UNITED STATES PATENT AND TRADEMARK OFFICE

APPLICATION NO.	FILING DATE	FIRST NAMED INVENTOR	ATTORNEY DOCKET NO.	CONFIRMATION NO.
10/598,155	09/21/2006	Gorm Sorensen	41081	1684
116 7590 02/25/2010 PEARNE & GORDON LLP 1801 EAST 9TH STREET SUITE 1200 CLEVELAND, OH 44114-3108				
EXAMINER				
MICHALSKI, SEAN M				
ART UNIT		PAPER NUMBER		
3724				
MAIL DATE		DELIVERY MODE		
02/25/2010		PAPER

Office Action Summary

DETAILED ACTION

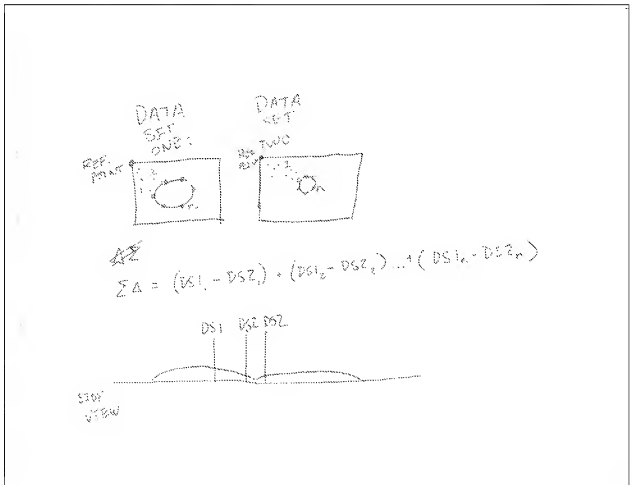
The specification describes essentially that the cross sections of the pieces are measured and that a change will indicate that there is a boundary/transition point. This is not enabling, however, because it does not take into account what the specific parameters of the computing methodology and measurement resolution are—information necessary to make and use the invention. Especially since food products are to be used which may have cross sectional variation *within* a piece (such as a chicken breast) making false boundary/transition point indication highly probable; and/or very uniform cross section (such as formed sausage product or pressed meat) making the boundary/transition point imperceptible. The specification does not provide any framework to establish the parameters of the control/measurement to make and use the device in accordance with the claimed "no gap" between items.

The specified "method" of "detecting a boundary" is to measure the size of the piece at a cross section (at radial points 1, 2, 3, 4, n... exactly as in Whitehouse) and then to compare those positions/ distances to adjacent distances (1', 2', 3' 4', n') and then measure the difference and sum the total. This way when the piece decreases in cross sectional area *all the points of measurement* decrease and the summation of the differences spikes up (since the differences are larger).

This is flawed, since any cross sectional change can trigger the same spike as it is alleged a boundary will do, and yet the application provides no way of being able to determine what are true boundaries and what are false positives. there is no way the direction of comparing the sum of the differences can lead to actual repeatable boundary detection without undue experimentation.
